LOT LINE ADJUSTMENT AND CONSOLIDATION PLAN FOR AL-AHAD ISLAMIC CENTER

MINOR PLAN 2023-204

REQUEST FOR PRELIMINARY/FINAL PLAN REVIEW

Lot Line Adjustment Plan Review

S-1

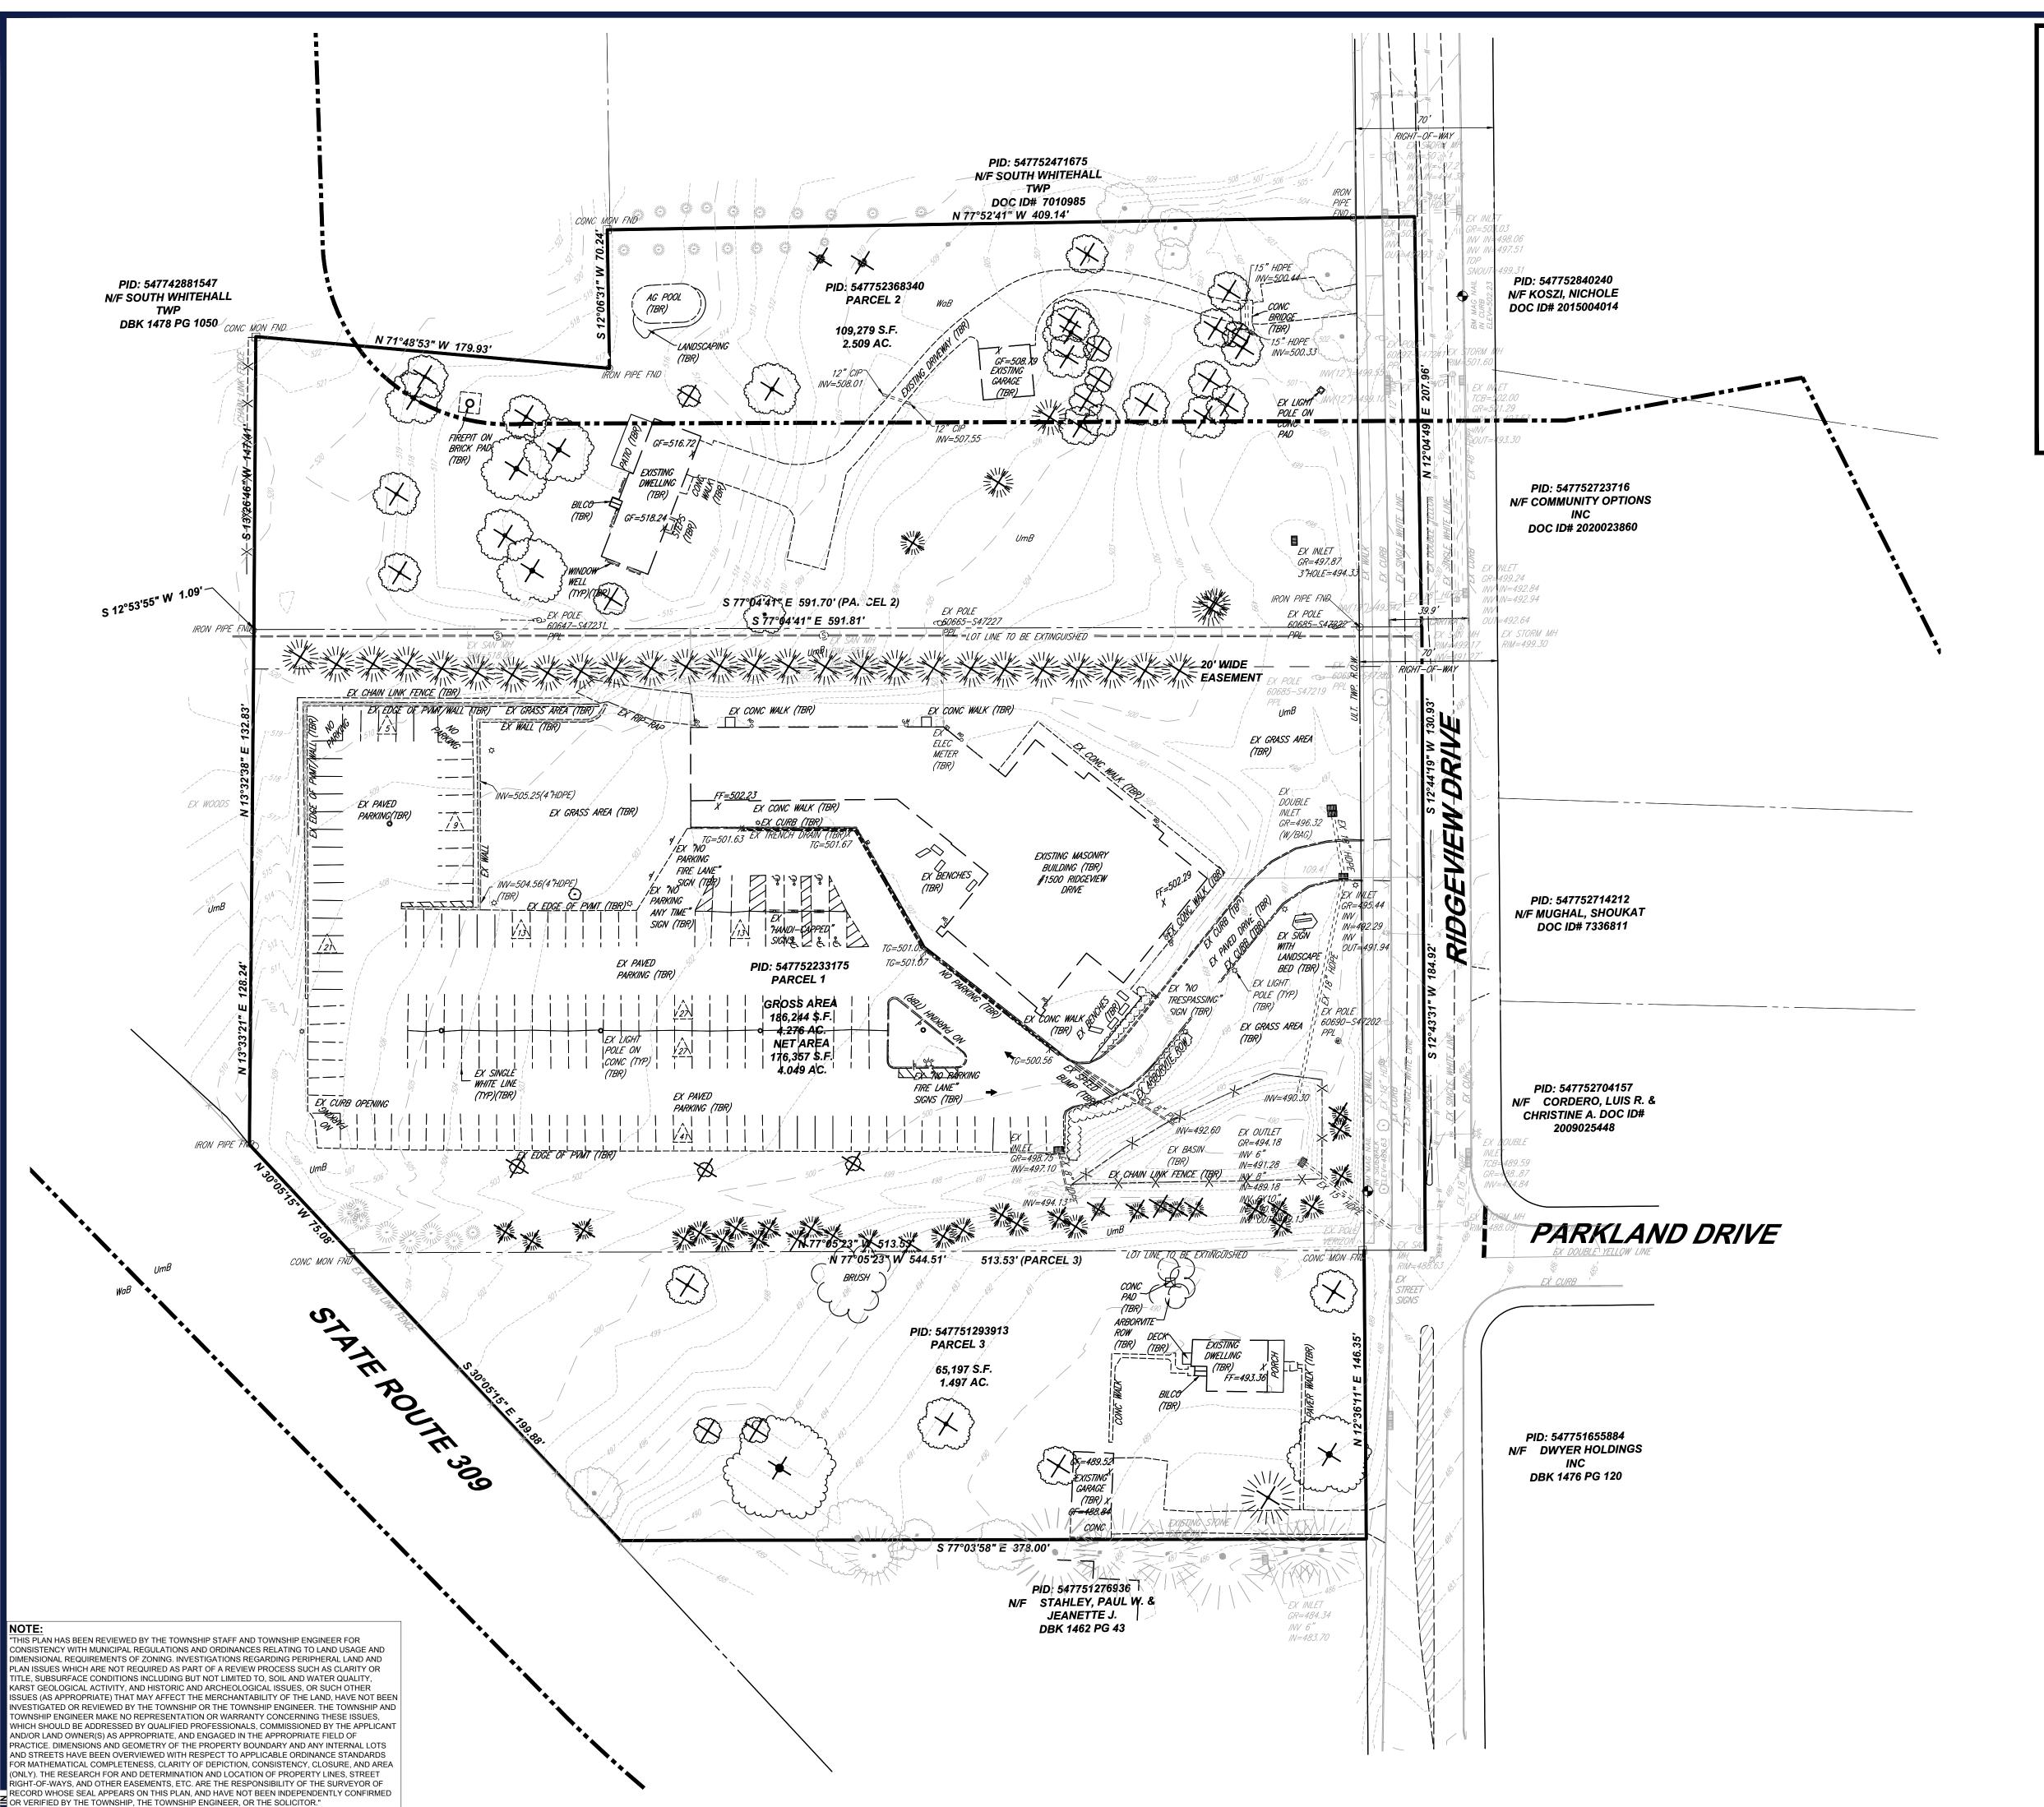
- d. Add Zoning Districts to the Location Map, SALDO §312-23(b)(11)(d);
 - e. Identify the location of the benchmark on the Plan, SALDO §312-23.B(16);
 - f. Show the locations, size and owners of existing buildings, sewer mains, water lines, etc., within 100 feet of the tract, SALDO §312-23(b)(19);

- g. Show the location, character, and elevation of any building within 100 feet of the tract, SALDO §312-23(b)(20);
 - h. Show the locations and widths of all sidewalks, trails, driveways, streets, easements, etc., within 400 feet of the tract, SALDO §312-23(b)(21);

1. Please indicate the sewer easement on the plan.
